DESIGN ADVISORY BOARD Tuesday, September 26th, 2017 at 3:00 PM Conference Room 12, City Hall, Burlington, VT Agenda

1. 18-0279CA; 184 Locust Terrace (RL, Ward 5S) Gabrielle Stebbins

MEMORANDUM

To: The Design Advisory Board
From: Mary O'Neil, AICP, Principal Planner
RE: ZP18-0279CA; 184 Locust Terrace
Date: September 26, 2017

Locust Terrace streetscape, current view. Subject house is right of center. Note similarity of style, massing, and setback.

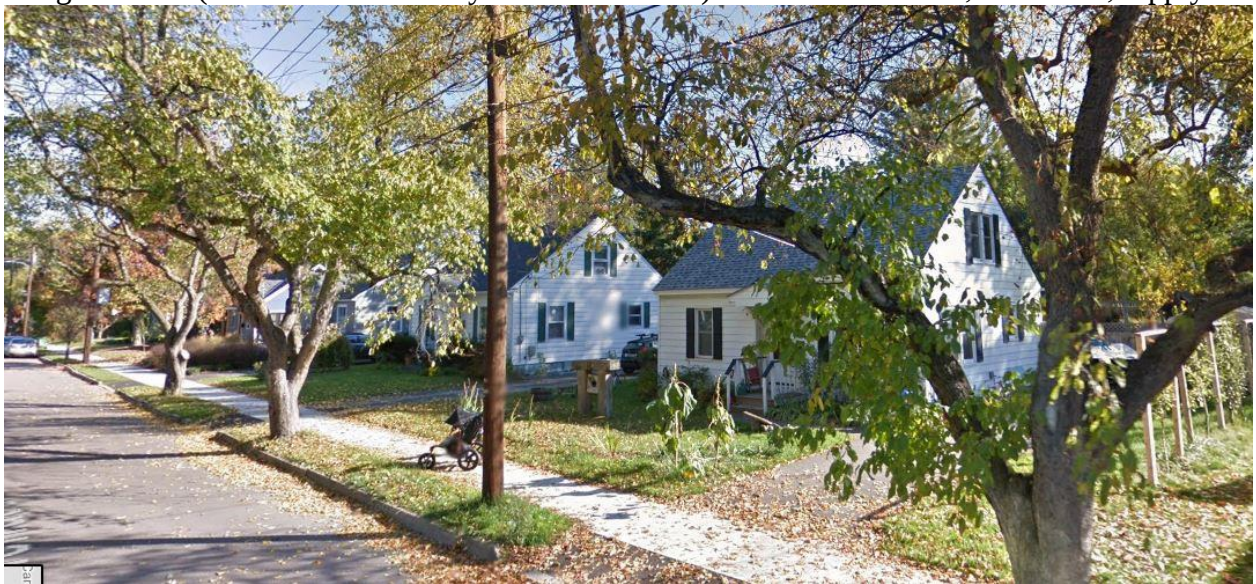
The 2007 Historic Sites and Structures Survey for the Five Sisters Neighborhood ("New Harlam") considered the neighborhood in its totality and determined a high degree of architectural integrity and merit within its context. Locust Terrace was Phase III of the neighborhood buildout, and the only phase constructed post WWII. This building is among more than 224 properties surveyed; 202 within that project determined to be eligible for historic designation. (See attached survey documentation.) These standards, therefore, apply.

C100

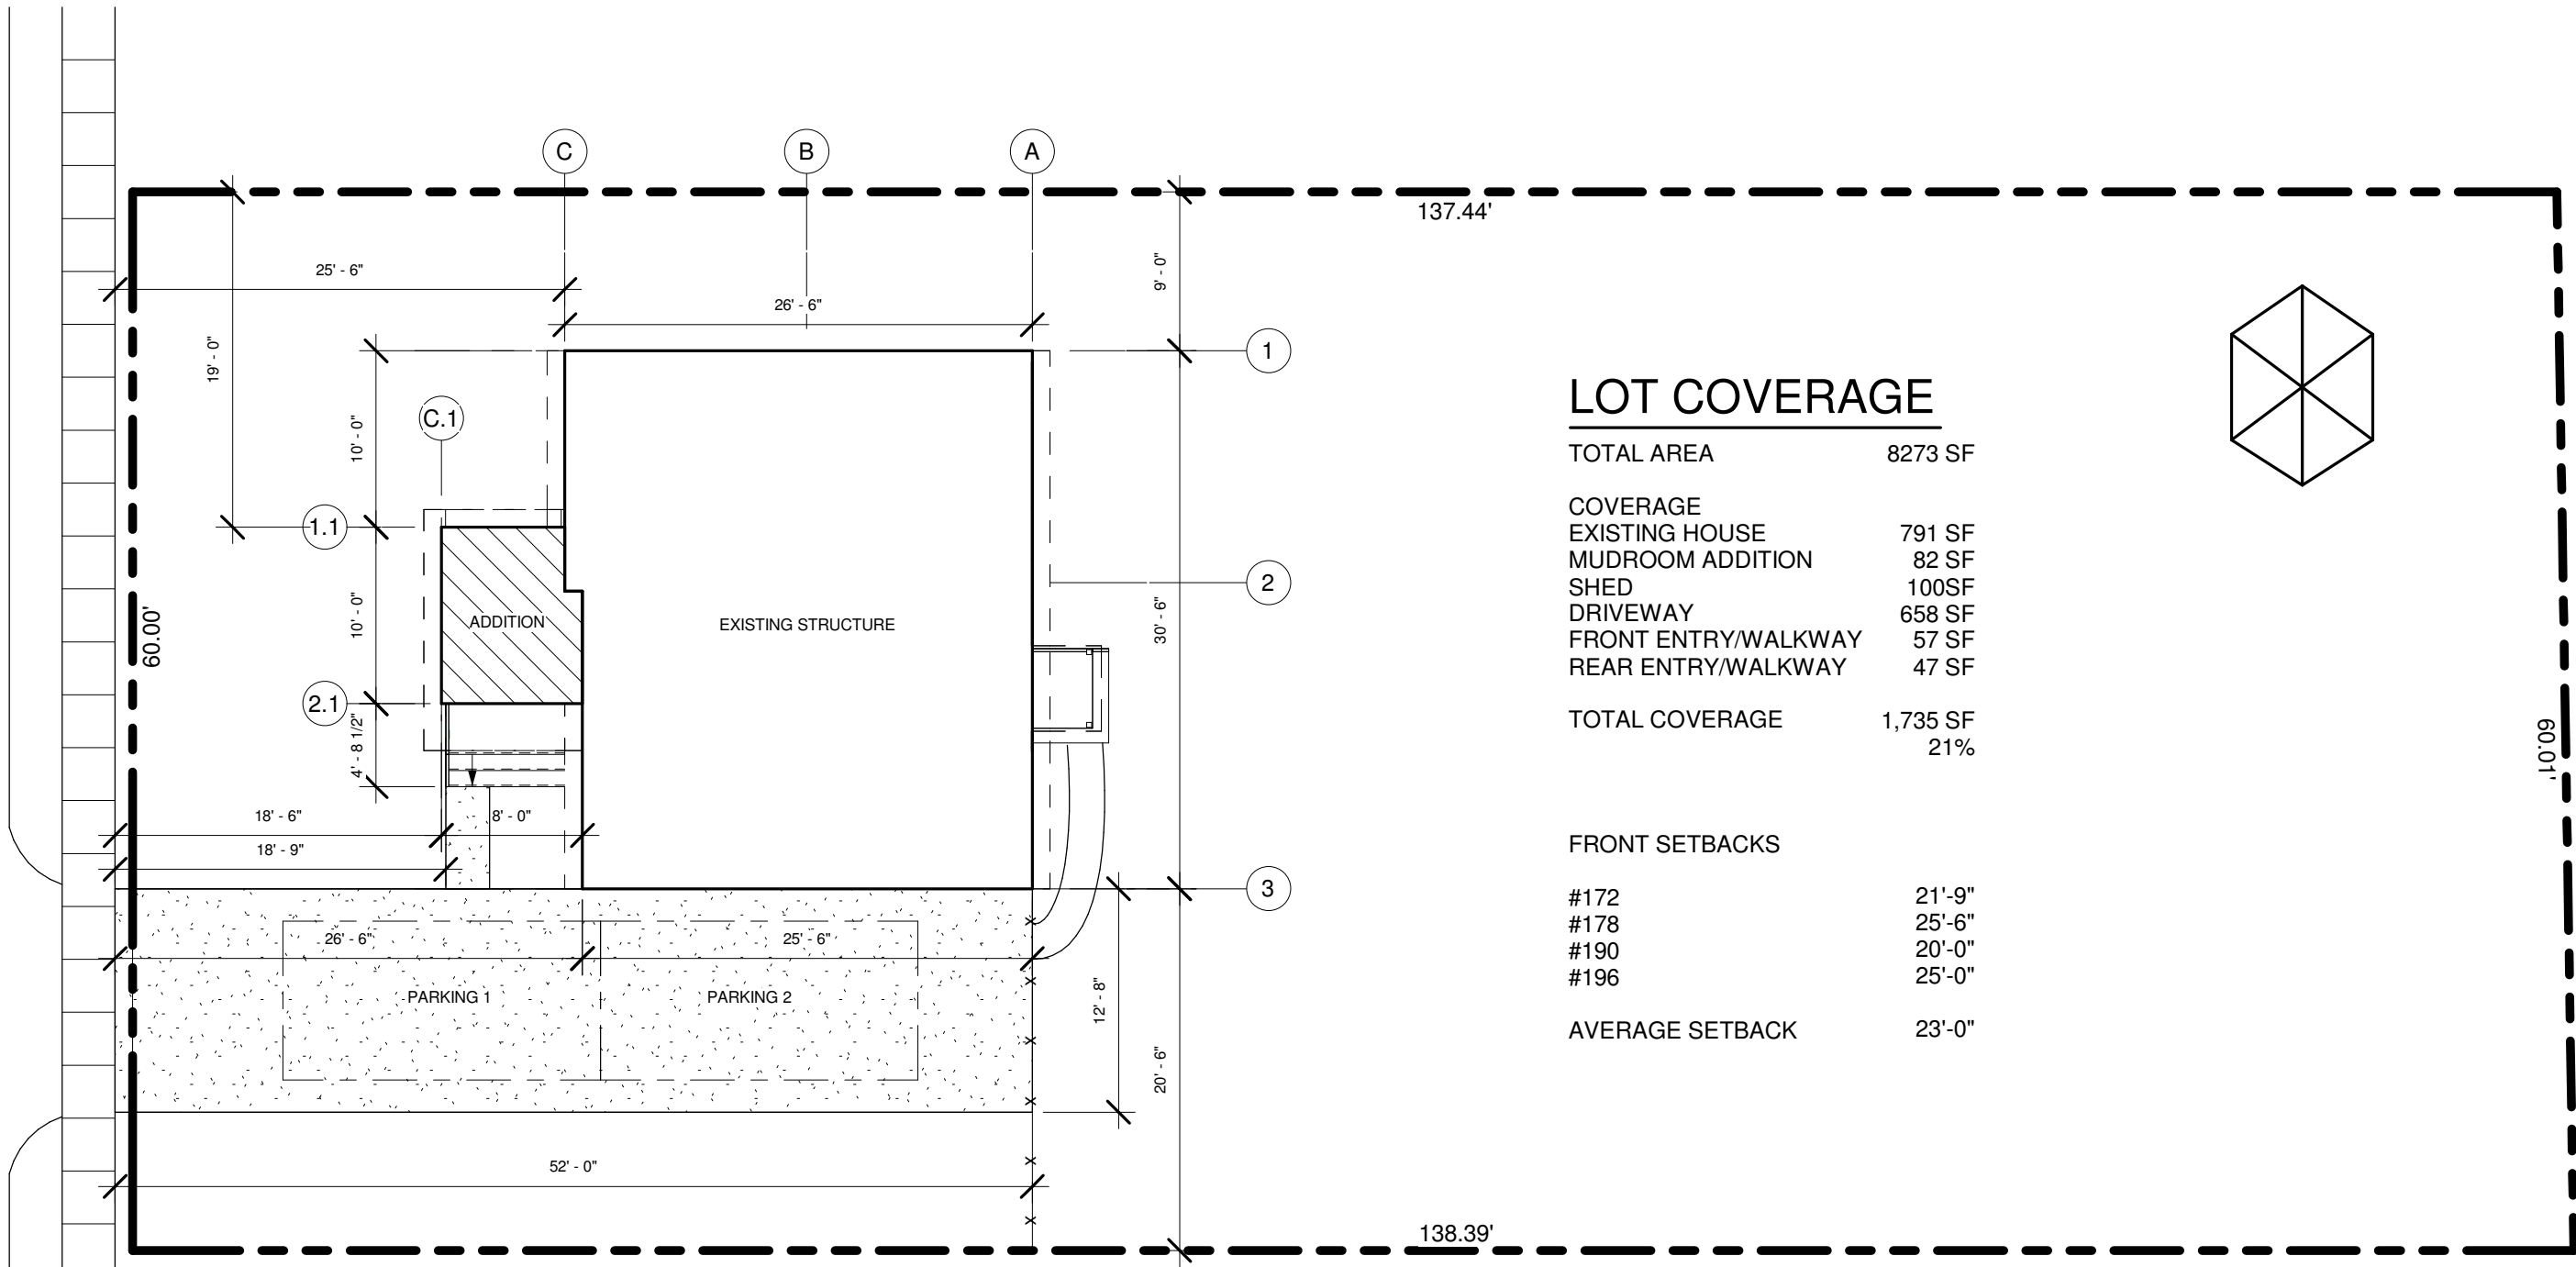
1. A site plan dimensional concern is the failure to observe a required front yard setback. (Article 4, **Table 4.4.5-3: Residential District Dimensional Standards.**) The average of front yard setbacks on adjacent lots on both sides is 23'. (21'9", 25'6", 20', and 25'.) Setback averages allow a +/- 5' deviation, creating an acceptable front yard setback range from 18-28' from the front property line. The proposed mudroom is 16'5 ½ "from the front property line; not within the range and therefore non-compliant.
